Subject: Fwd: Extremely urgent! Aluminium Doors

Planning

DT0002 'Elberry', 70mm Std 950mm x 2100mm, Open IN, Hinge R, 62mm frame, threshold SPD703

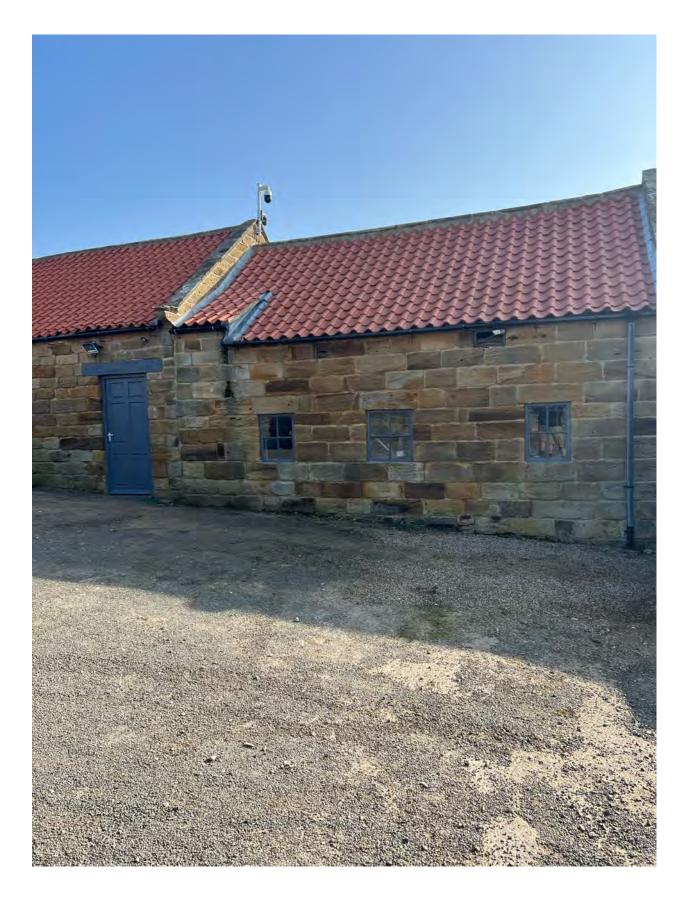
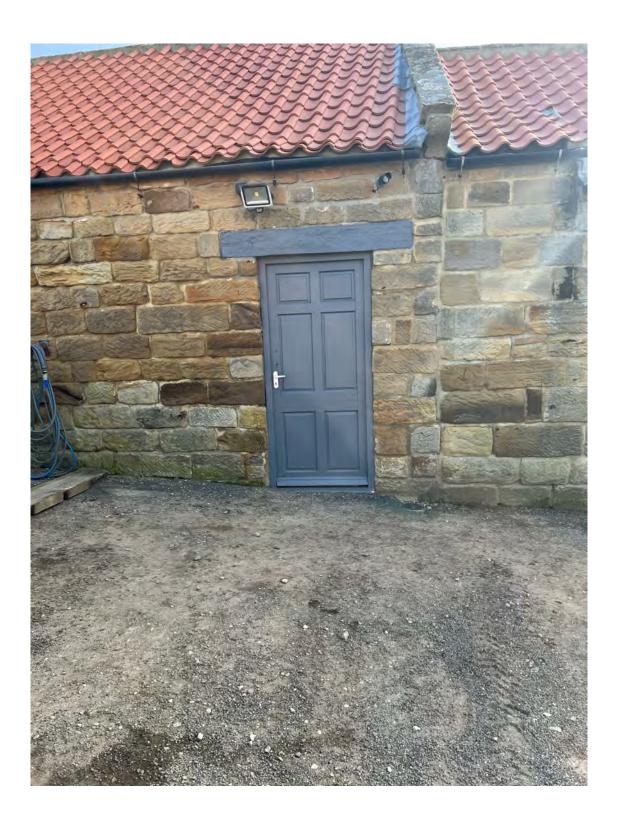
This door the Elberry is what we would use for D8

Granted it doesn't have the vertical panels in the bottom but as you can see from the other existing doors in the yard that we currently have they have less panels and more in keeping with the current buildings. Lead strips would be included in the window to give the same effect as the other 2 windows W1 &W2.

Alternatively we are happy to go with full glazed for this opening or the Purton.
